4-13-09  
Comp. Call 0830  
GP  
ARCADIS  
MDEQ  
EPA

# Proposed Scope for Focused Cleanup of Plainwell No. 2 Dam Area

April 13, 2009

# Removal Segments with Max PCB > 50 mg/kg

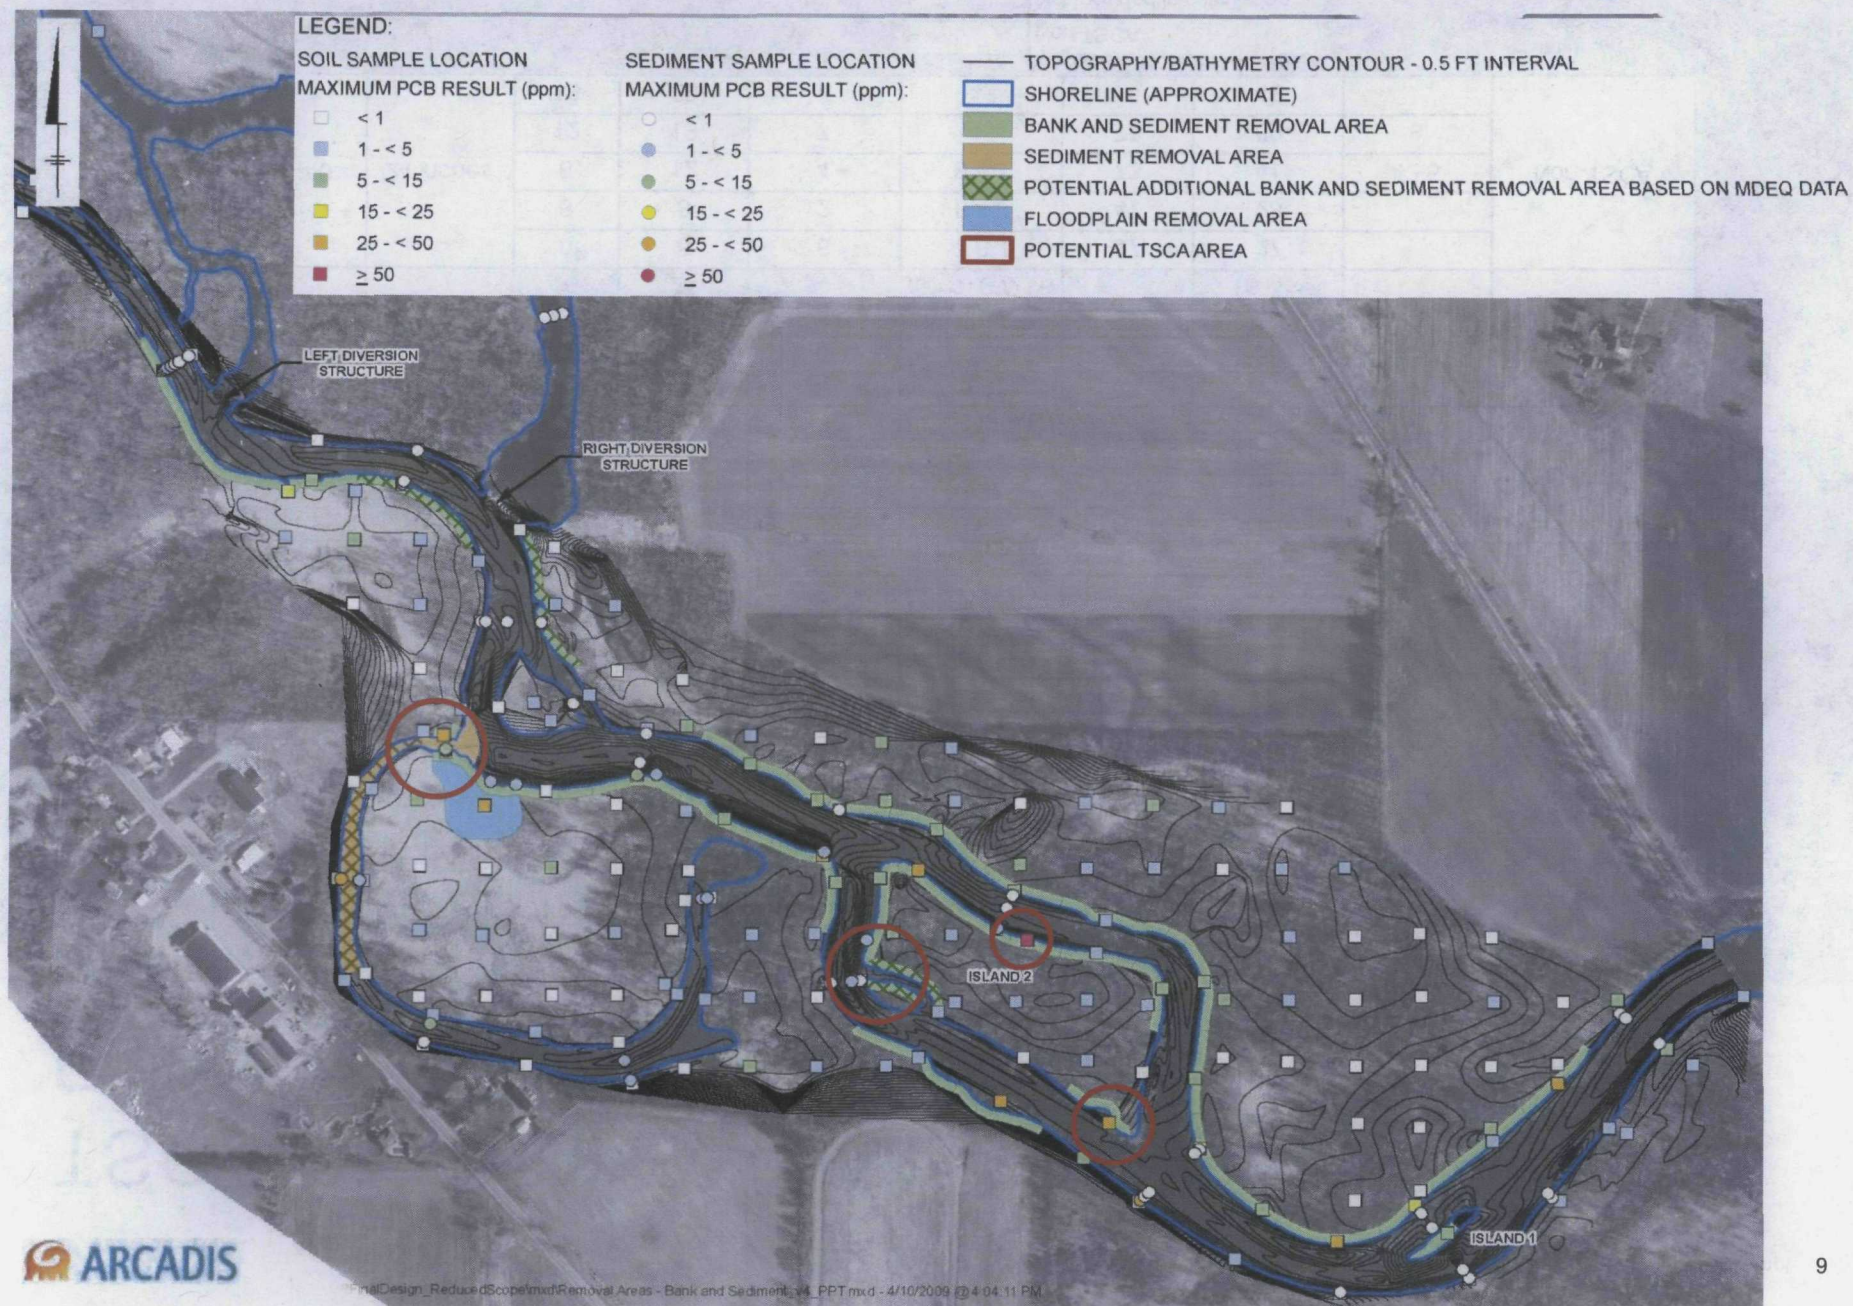
*Big Issue for GP.*

*Fox River 30" protocol was for a incineration sediment removal w/ cutter head dredge vs. bank and excavation*

*GP doesn't want to change this afraid of setting precedent w/ 12" lifts on future work*

*GP - gather disposal facilities permit and review the designation of PCB waste (i.e. definition).*
